AREAS OF MODIFICATION BETWEEN APPROVED DRAINAGE GRADING PLAN AND ACTUAL AS-BUILT

PROJECT: OFFICE WAREHOUSE FACILITY
LOCATION: COLUMBINE AVE. NE
ALBUQUERQUE, NM
OWNER: JOHN MECHENBIER

DRAINAGE / GRADING PLAN

ARCH. SEAL ENGR. SEAL SHEET: C-1

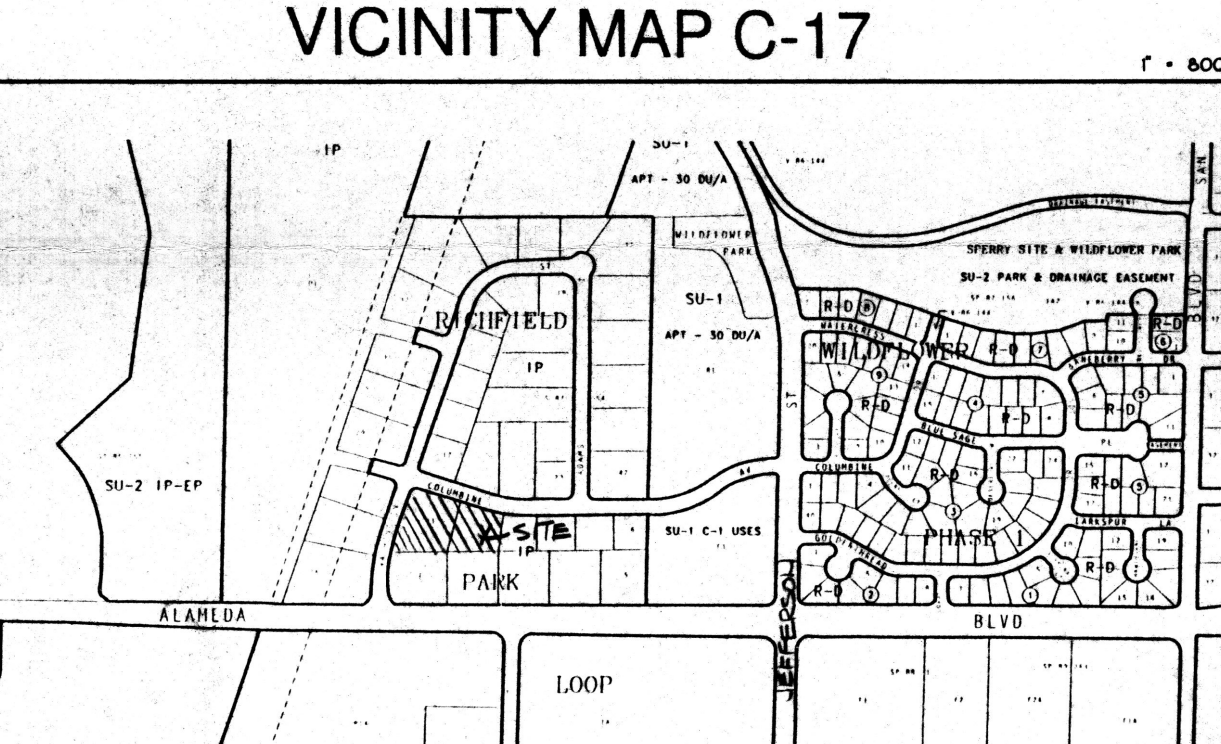
1. Parking Island / Landscaped area not constructed. Does not affect Drainage / Grading.

2. High point in paved area moved south. Very flat grades. Minimal slope to drain this area.

3. Landscaped area configuration not constructed per plan. Does not affect Drainage / Grading.

I, Christopher L. Weiss, P.E. hereby certify that the as-built information shown is in substantial compliance with the approved drainage / grading plan.
